5000 12TH AVE NE

8.0 ITEMIZED RESPONSE TO EDG

8.0 ITEMIZED RESPONSE TO EDG

2d 2. ARCHITECTURAL CONCEPT

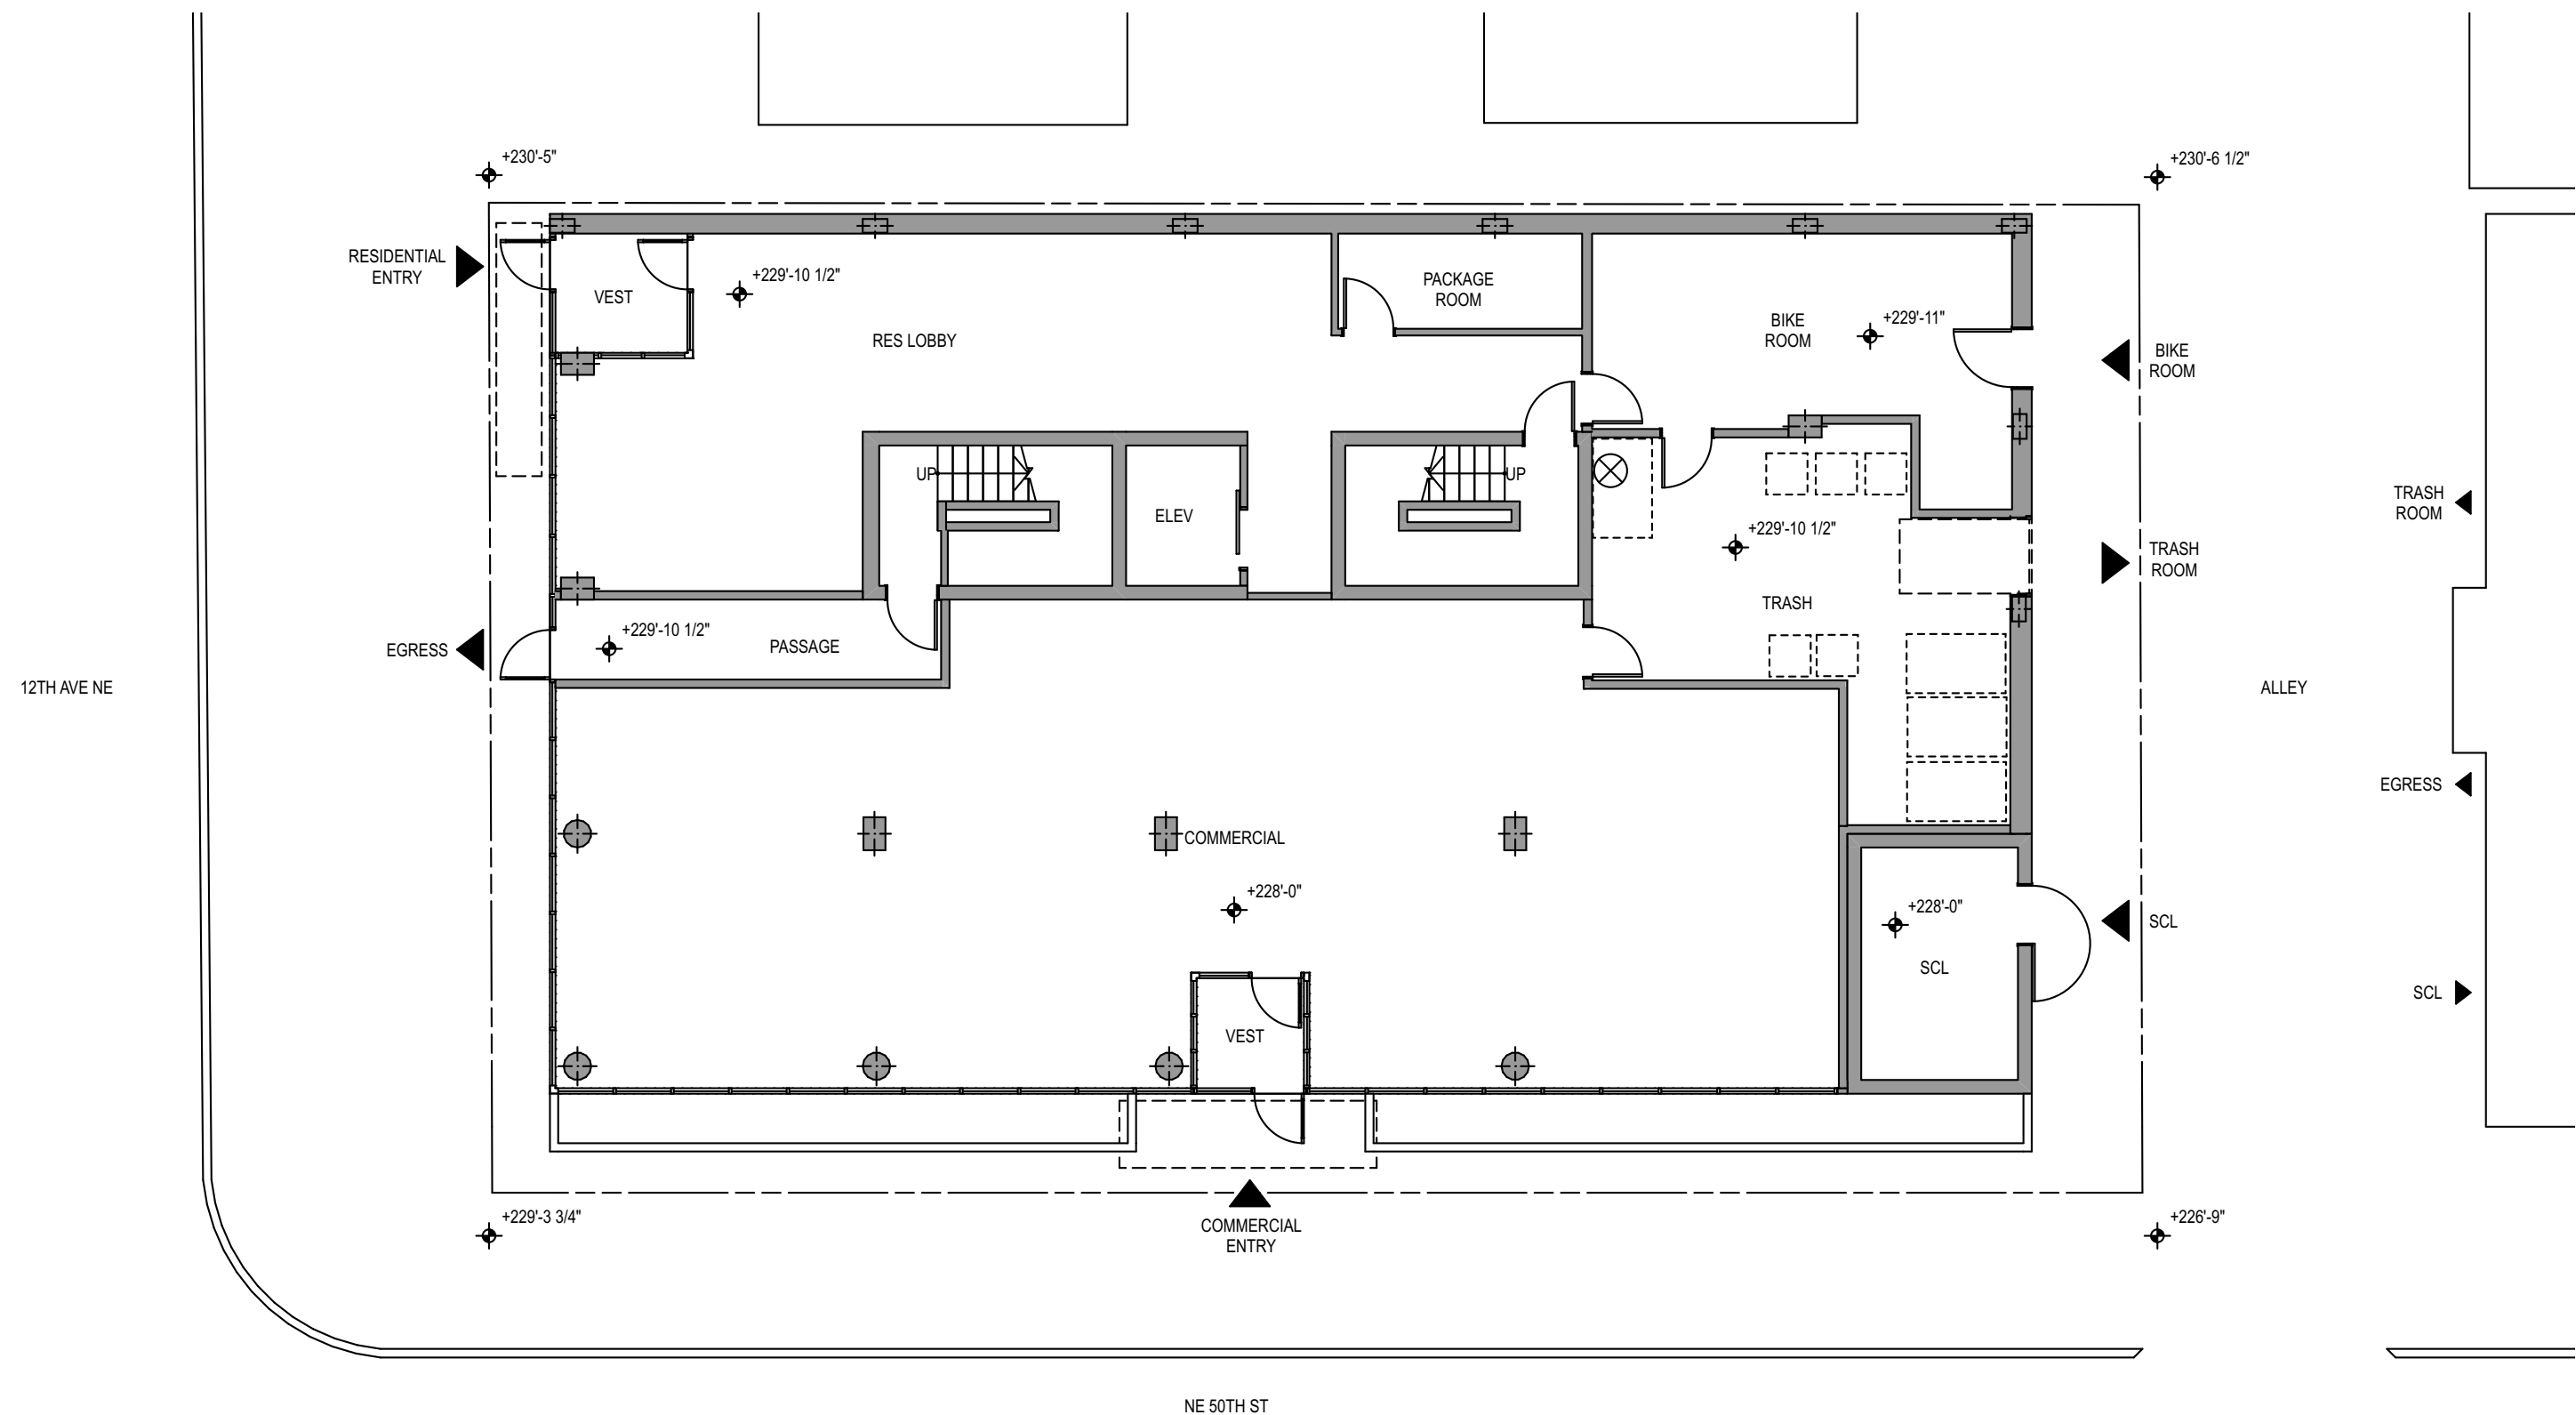
d. The location of the residential entry on 12th Ave NE is logical and assists with the transition from the commercial uses on NE 50th Street to the smaller-scale residential character of 12th Ave NE. However, the sites NE 50th Street address may lead to some way finding confusion, as visitors are likely to first approach the building from NE 50th Street. Use materials, lighting, landscaping, and other secondary elements to create an entry that is easily identifiable from the corner of NE 50th Street and 12th Ave NE. (PL2-D-1, PL3-A)

Response: The commercial entry has been moved to NE 50th St to create continuity with the commercial character of this street. This entry has its own canopy for wayfinding and landscaping/bio-retention planters have been designed around the base of the building and storefront to help direct individuals to the residential entry off 12th Ave NE. The residential entry has its own canopy to enhance its visibility and place of importance.

3a 3. OPEN SPACE

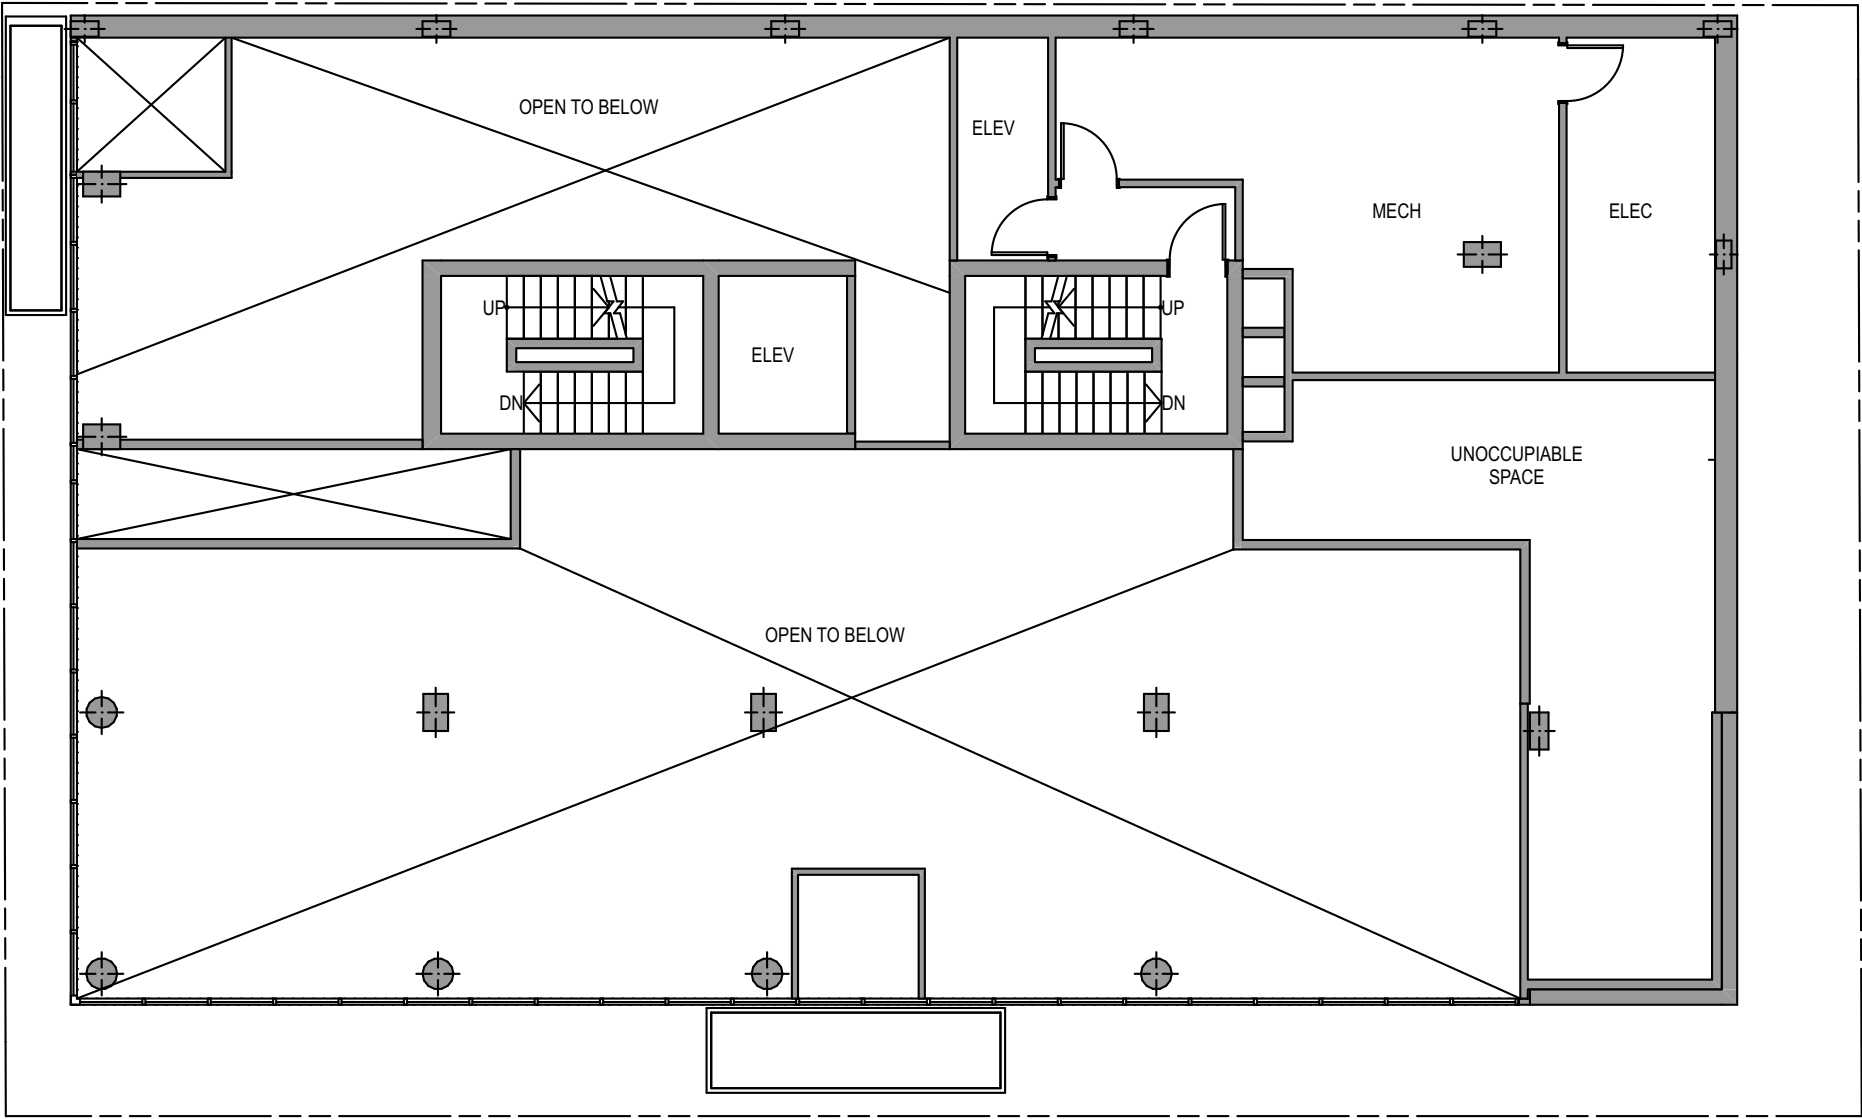
a. The roof deck includes abundant landscaping, providing a comfortable amenity area for residents. Trees are recommended, as shown, as a way of providing some shaded areas during the summer months. Retain a similar ratio of landscaping to hard surface in the MUP plan set. (DC3-B, DC3-C-2)

Response: The landscaping on the roof has been retained from the EDG set and enhanced with a central bbq space for social gatherings. Further, raised planters have been designed to generate multiple spaces for groups of different sizes on the compact roof area. The green roof area has been expanded from the EDG packet to help improve the feel and character of the space while helping to mitigate storm water runoff for the building.
